APS/SDG&E Interconnection Project

Final Environmental Document

COMBINED ENVIRONMENTAL DOCUMENT
ENVIRONMENTAL IMPACT STATEMENT (EIS)
ENVIRONMENTAL IMPACT REPORT (EIR)

APS/SDG&E INTERCONNECTION PROJECT
MARICOPA & YUMA COUNTIES, ARIZONA
and
IMPERIAL & SAN DIEGO COUNTIES, CALIFORNIA

Figure 1

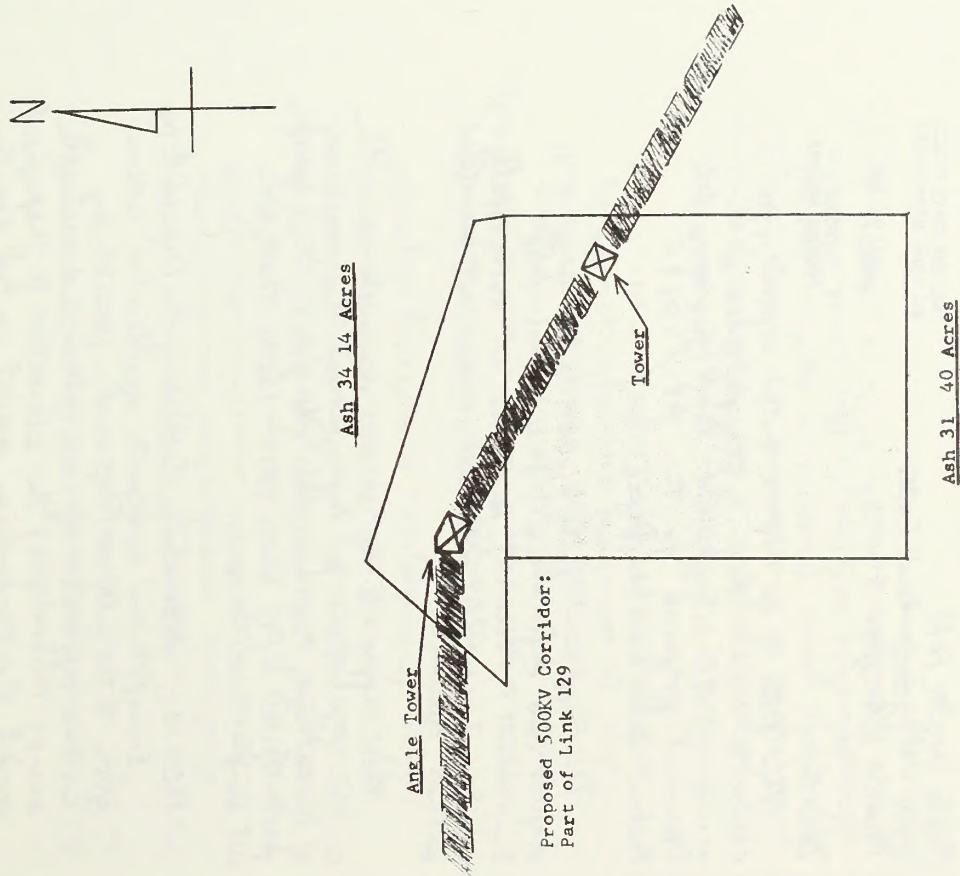
[of the field, it will be very difficult to successfully farm this small field. (See Fig. #1.) In addition to the possible agricultural loss in this field, it is also probable that this field could never be used as a homesite because of the existence of the transmission lines. When I purchased this property I had plans of building a home and farm shop sometime in the future.]

E [Your comments have been noted and will be considered in the final decision.
